**STATE OF KANSAS  
BEFORE THE DIVISION OF WATER RESOURCES  
KANSAS DEPARTMENT OF AGRICULTURE**

**Case No. 18 WATER 14014**

**Expert Report by Tim Boese  
for  
Equus Beds Groundwater Management District No. 2**

The City submitted to the Chief Engineer a proposal titled "ASR Permit Modification Proposal Revised Minimum Index Levels & Aquifer Maintenance Credits" (Proposal). The Proposal included a cover letter dated March 12, 2018, and also included supporting information. The Proposal requested that the following changes be made to the ASR Phase II approved water permits and also be applied to any pending or future ASR water permits:

Figure 1 Annual water level changes within the BSA before, during, and after drought as well as after 2 years of recovery

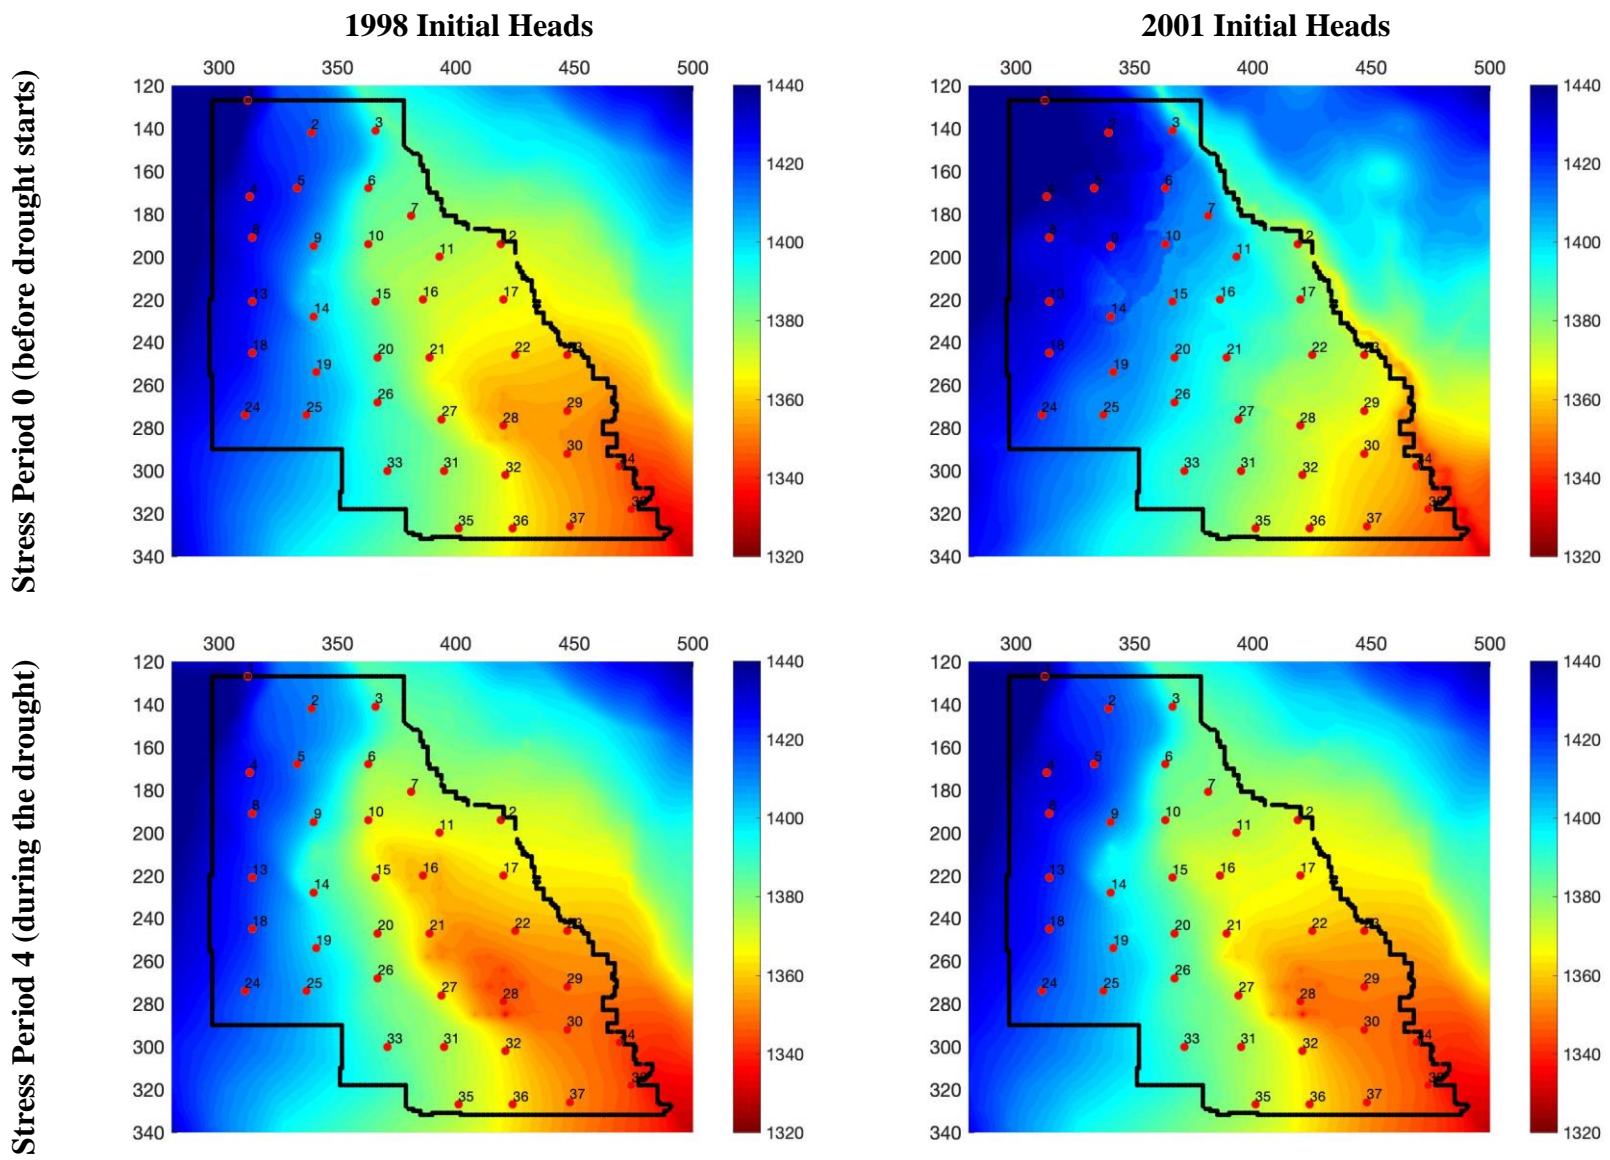
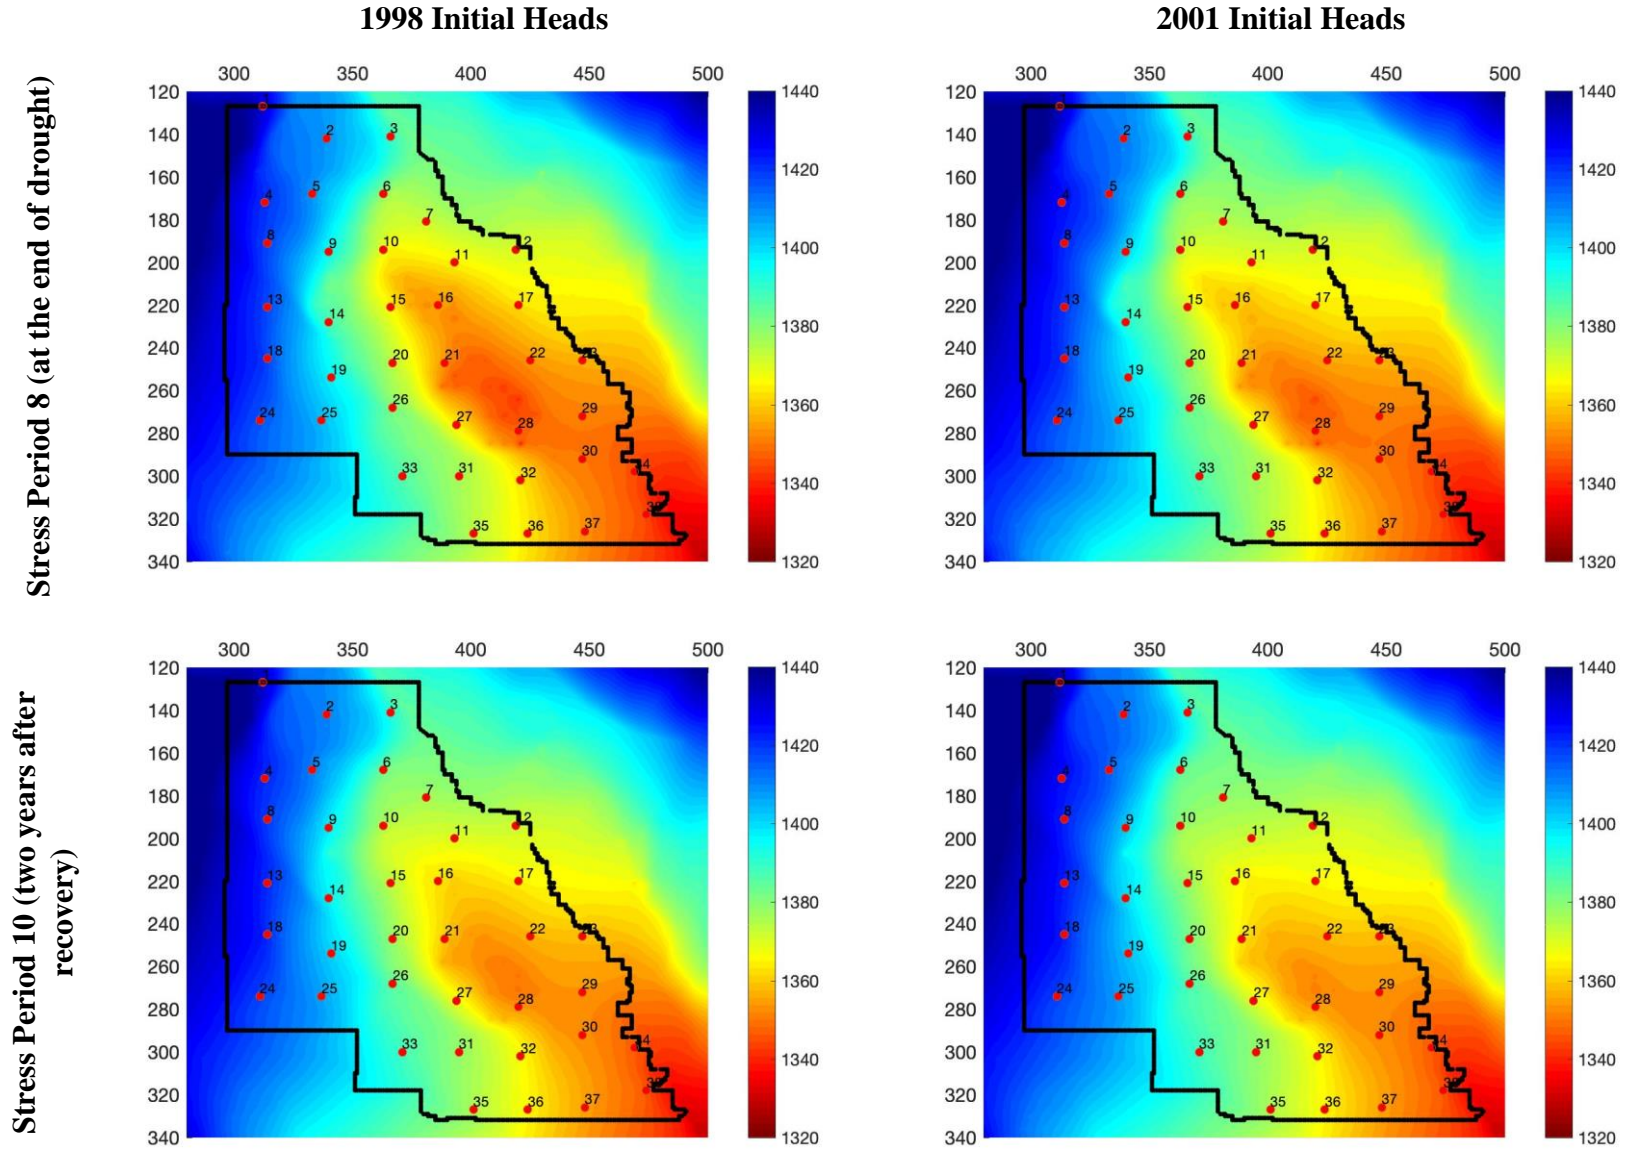
14. To evaluate water level changes resulted from the 8-year drought and the 2-year recovery periods, I ran the original form of the Drought Model, which has 1998 water levels data as its initial heads. I also updated the initial heads using the 2001 data and re-ran the Drought Model to evaluate the model's response to the updated initial heads. The average of 2001 initial heads over the location of the 38 index wells is about 11.85 ft higher than the original heads introduced to the model (from 1998). **Table 1** at the end of this report presents the *differences* between the 2001 and 1998 initial heads, as well as the resulted water table elevations (ft) during the 8-year drought and 2-year recovery periods. **Table 2** also shows initial heads and water table elevations during these periods at the location of the index wells.

15. **Figure 1** at the end of this report also depicts annual water level changes within the BSA resulted from both initial heads before, during, and after the 8-year drought as well as after the 2-year recovery period.

**Figure 2 Annual water level changes at selected Index Wells during the 8-year drought and 2-year recovery**

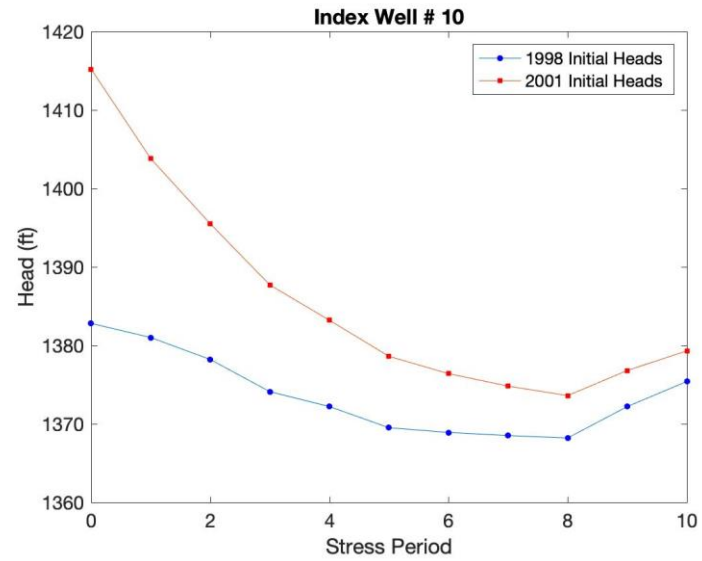
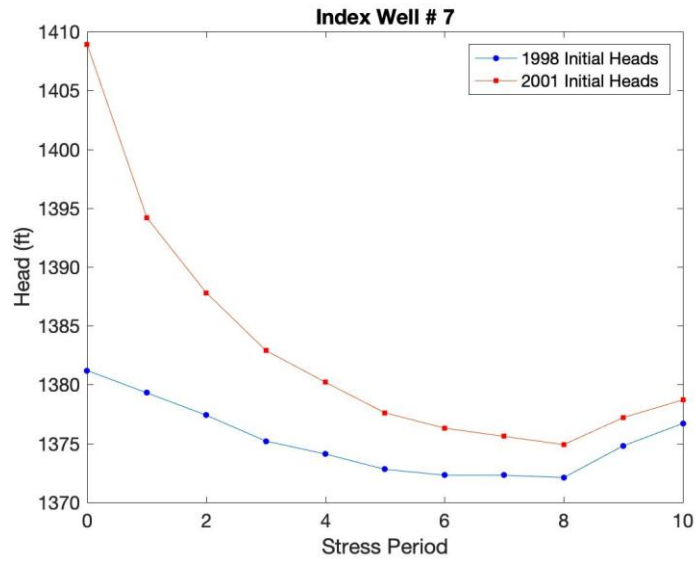
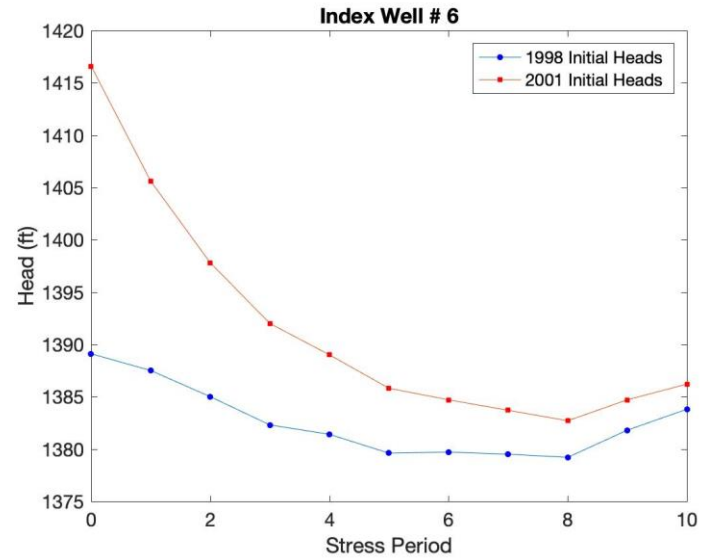
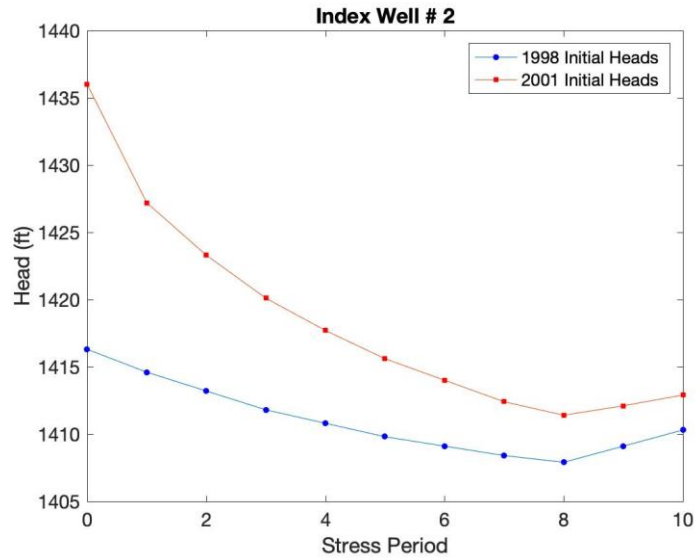
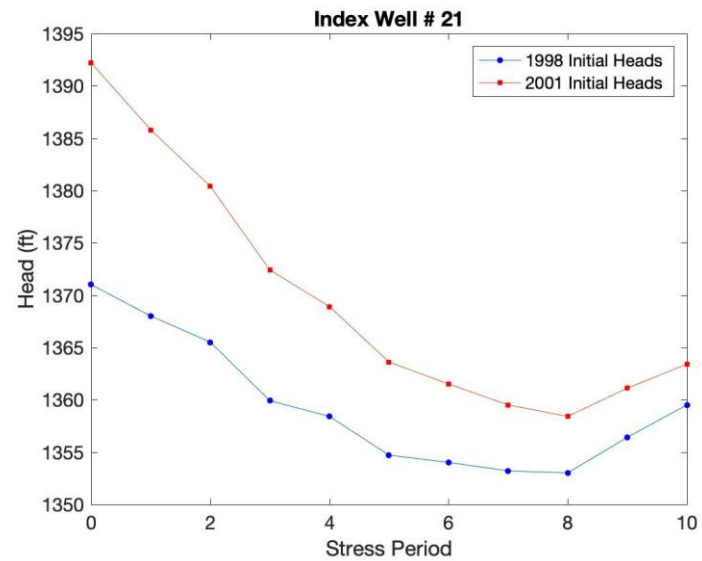
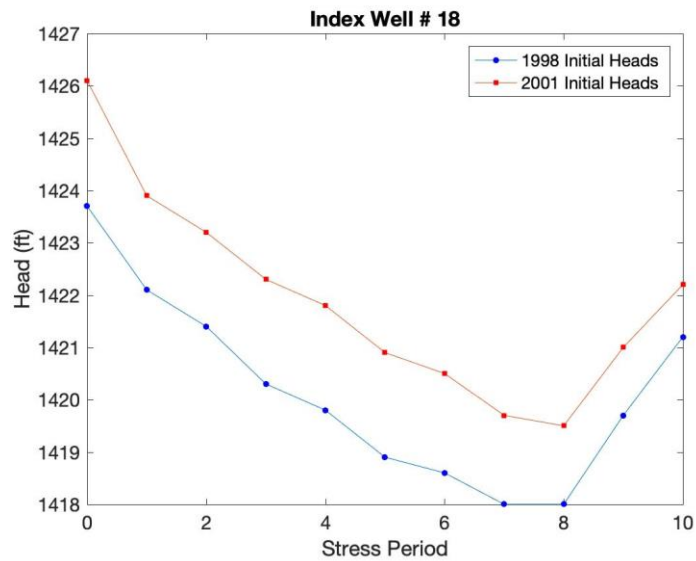
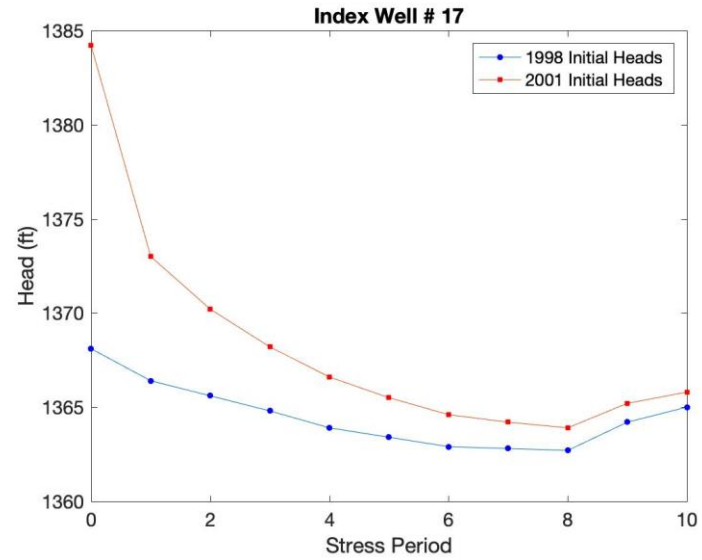
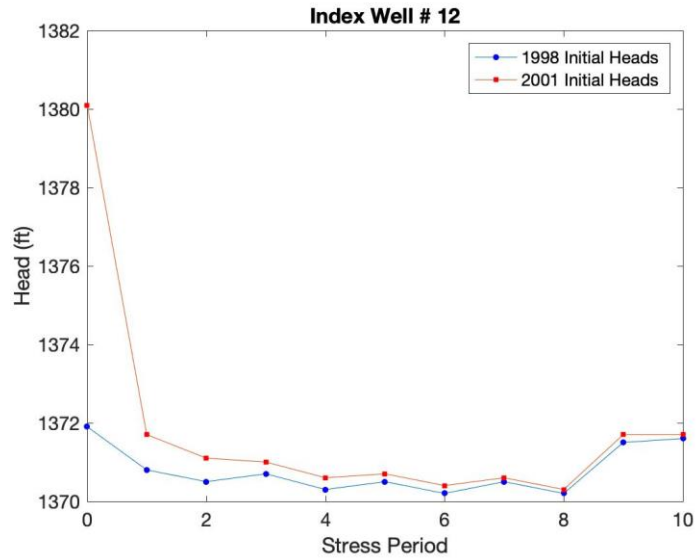
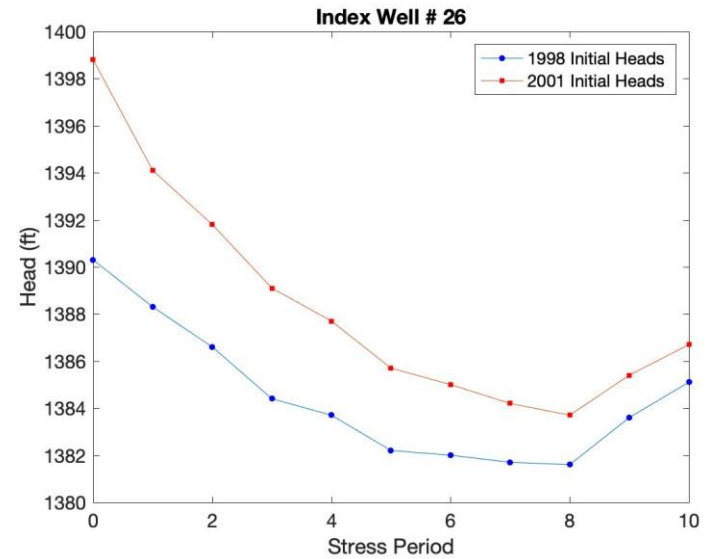
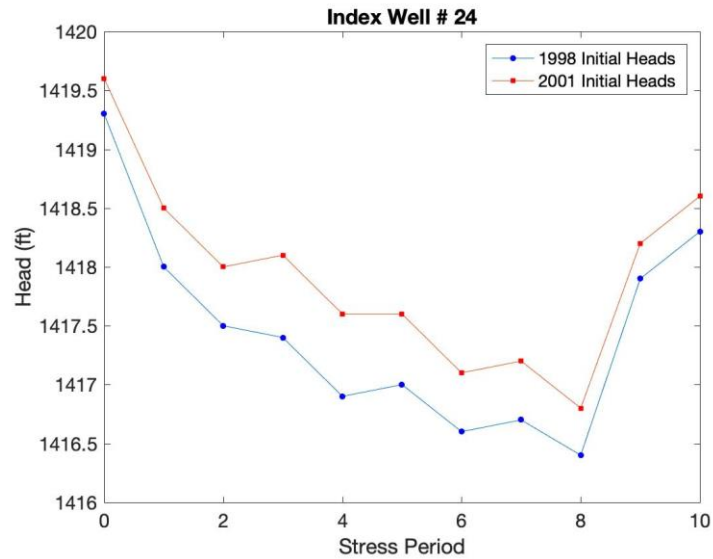
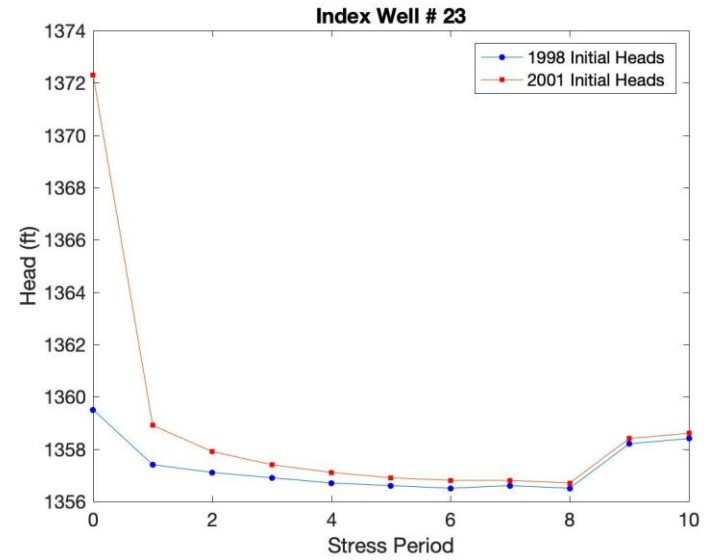
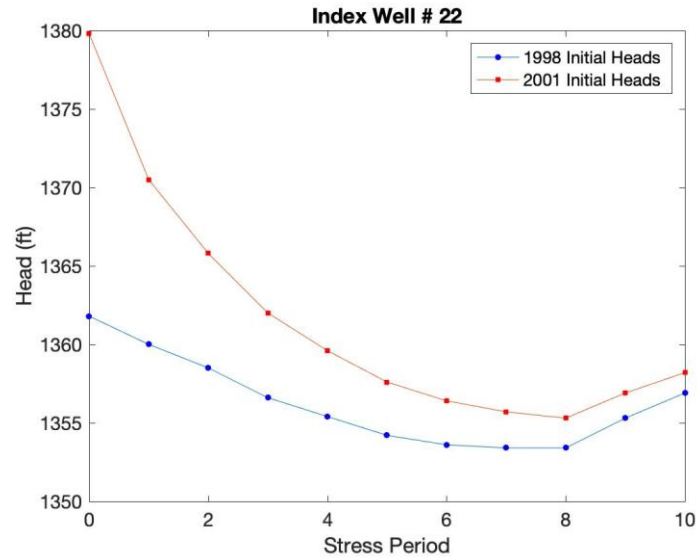
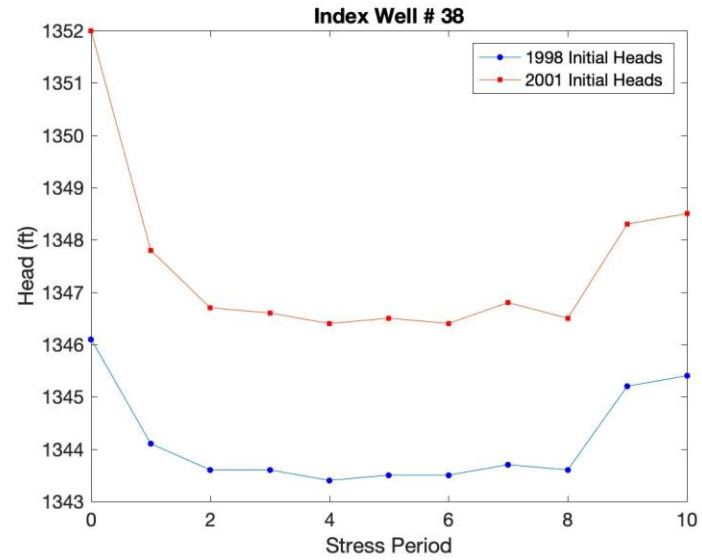
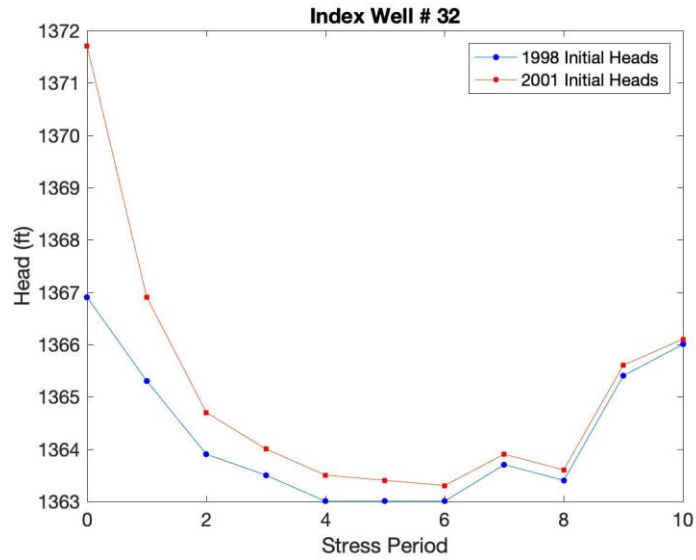
17. As presented in **Table 2** and illustrated in **Figure 2**, when initial water heads are updated with the 2001 data, which is on average 11.85 ft higher than the original heads, and all other boundary and initial conditions are kept unchanged, there is a steep drop in water level within the first year (from Stress Period 0 to Stress Period 1). This drop is significantly more substantial in the index wells closer to the east side of the BSA, where the water is drained rapidly into the Little Arkansas River, e.g. Index Well # 12. While this steep drop verifies the model performance, it emphasizes on the model sensitivity to boundary and initial conditions and highlights the importance of setting these conditions accurately. Inaccurate setting of these conditions may result in unwanted drainage or recharge of large quantities of water out of or into the aquifer.
